ADDENDUM NO. 01

July 24, 2026

**Bradford Exempted Village Schools
New Athletic Facility
760 Railroad Avenue
Bradford, OH 45308**

LPA PROJECT NO. 263401.00

FIRST FLOOR PLAN
A101

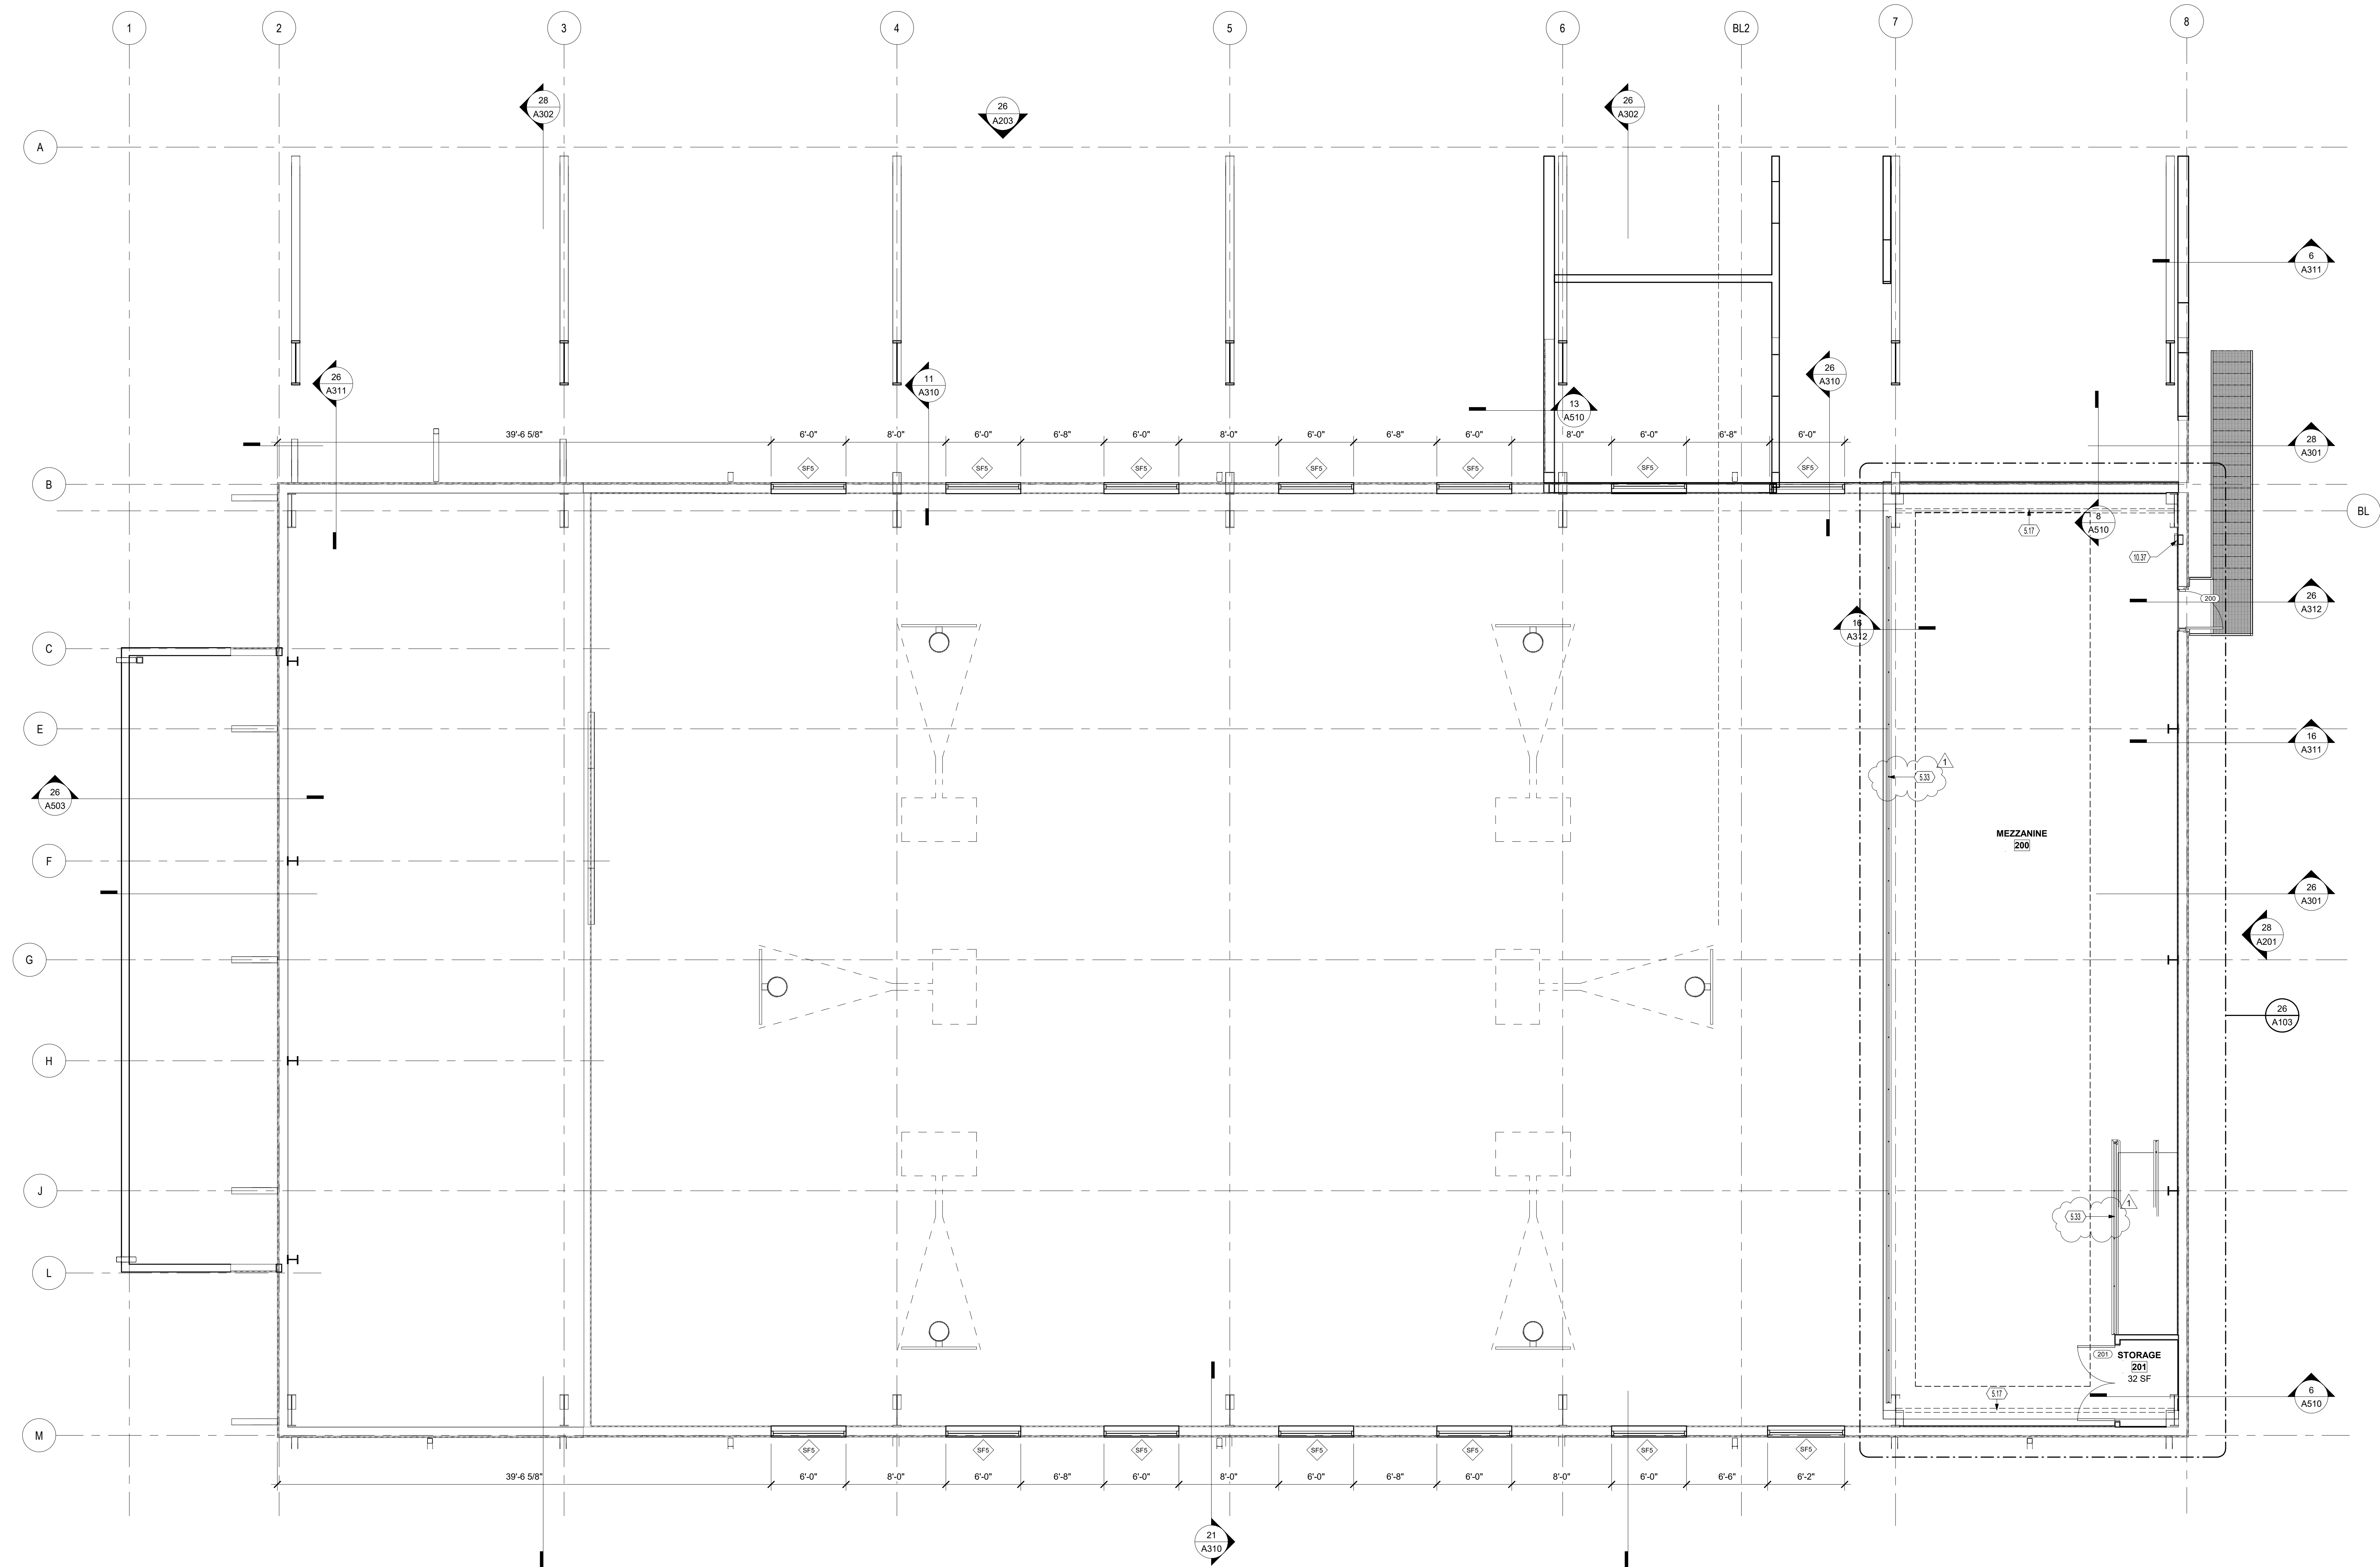
2.2 Sheet A101 – FIRST FLOOR PLAN.

- 2.2.1 Added Section 26/A503 for front entrance canopy.
- 2.2.2 Clarified note 5.08 indicating that gymnasium liner panel is Alternate G-5.

4.2 Clarification: The shower room slab shall be recessed 2" as indicated per note 3.18 on sheet A101. A mud slab shall be installed that slopes to the drain as indicated. The slab on grade in this area shall maintain the 5" thickness not including the mud slab.

26 ENLARGED GYM STRIPING PLAN
SCALE | 1/4" = 1'-0"

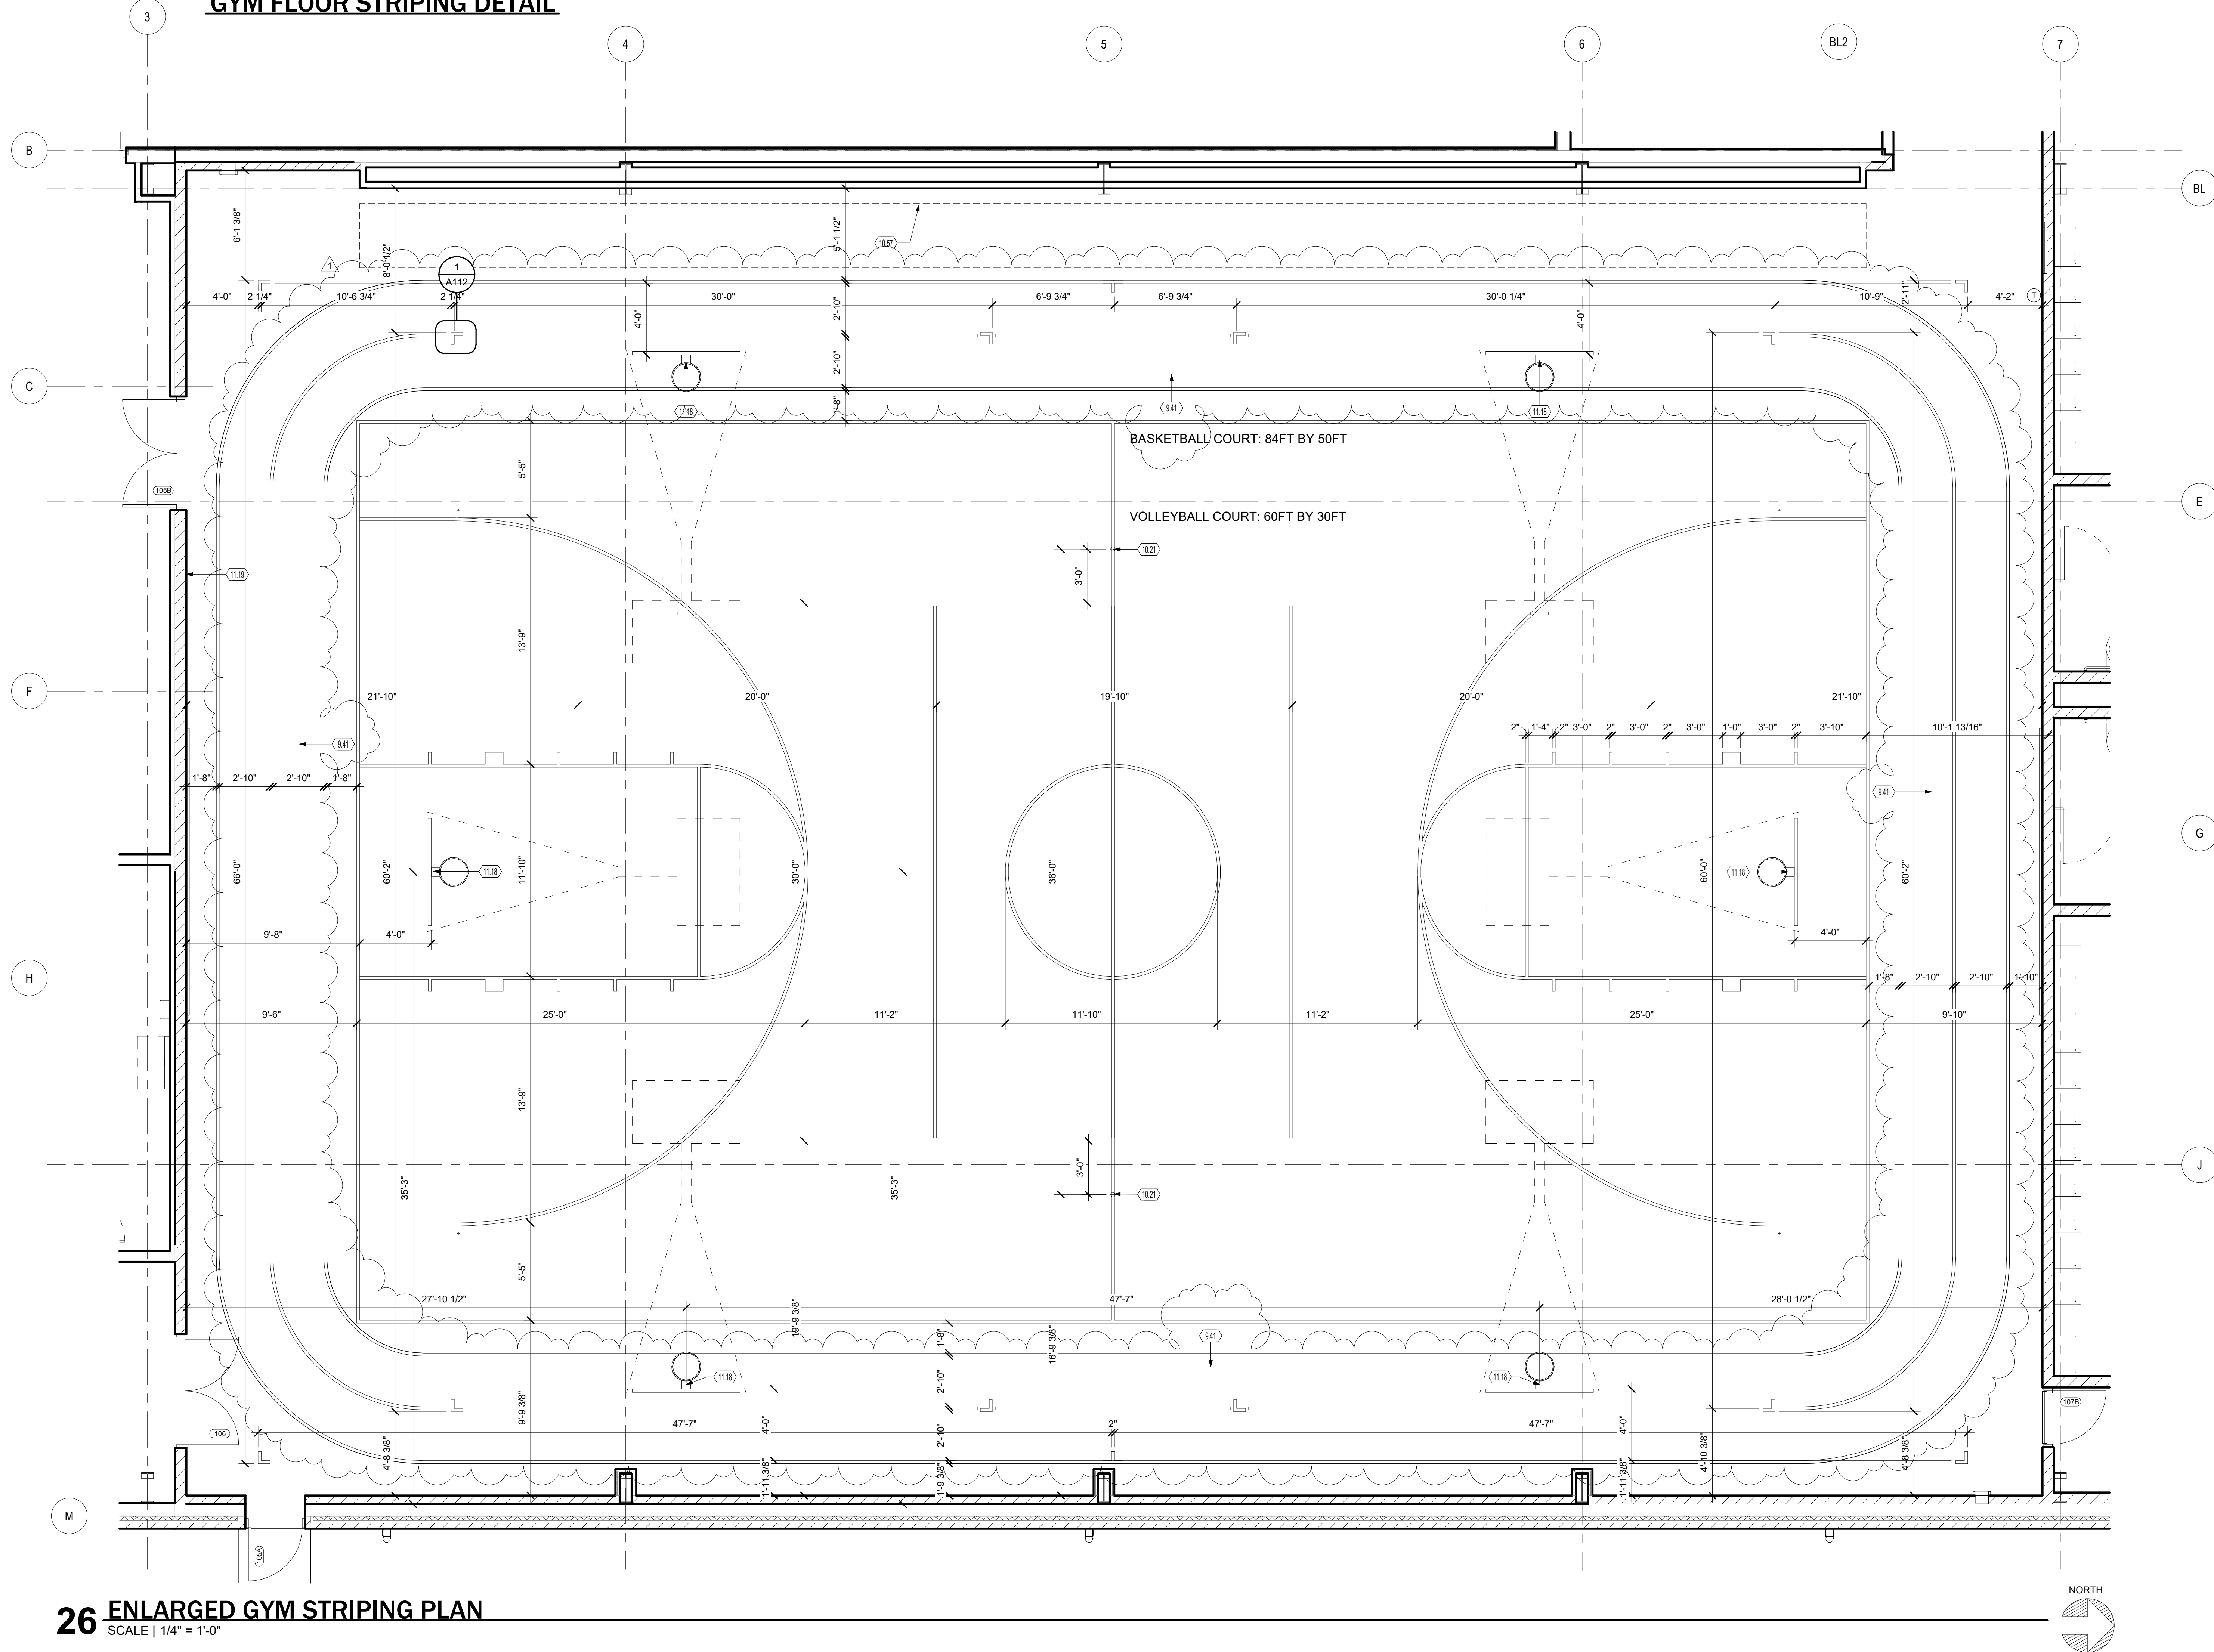
2.4 Sheet A112 – ENLARGED GYM STRIPING PLAN.

- 2.4.1 Added note 9.41 indicating that the walking track will be painted a contrasting color from the main gym floor.

- ### KEYNOTES
- 9.41 THE WALKING LANES SHALL HAVE A CONTRASTING COLOR FROM THE GYM FLOOR. COLORS TO BE DETERMINED.
 - 10.21 INSTALL SLEEVES FOR VOLLEYBALL NET POSTS AT MAIN VOLLEYBALL COURT. VOLLEYBALL EQUIPMENT NOT IN CONTRACT.
 - 10.57 LINE REPRESENTING BLEACHERS IN RETRACTED POSITION.
 - 11.18 PROVIDE AND INSTALL FORWARD FOLDING MOTORIZED BACKSTOP. NOTE: BACKBOARD, RIM AND BACKBOARD PADDING ARE BEING PROVIDED BY THE OWNER. THESE SHALL BE INSTALLED BY THE BACKSTOP PROVIDER. THE BACKBOARD, RIM, AND PADDING ARE BY BSN SPORTS. ITEM NUMBER NSPHS. MODEL OF74235E WITH BLACK PADDING.
 - 11.19 LOCATION OF FUTURE WALL MOUNTED SCOREBOARD PROVIDED AND INSTALLED BY OWNER. PROVIDE BLOCKING AND POWER ROUGH-INS. BASED ON DIAKTRONICS MODEL BB-2107 WITH PLAYER STAT PANELS MODEL SD-2102.
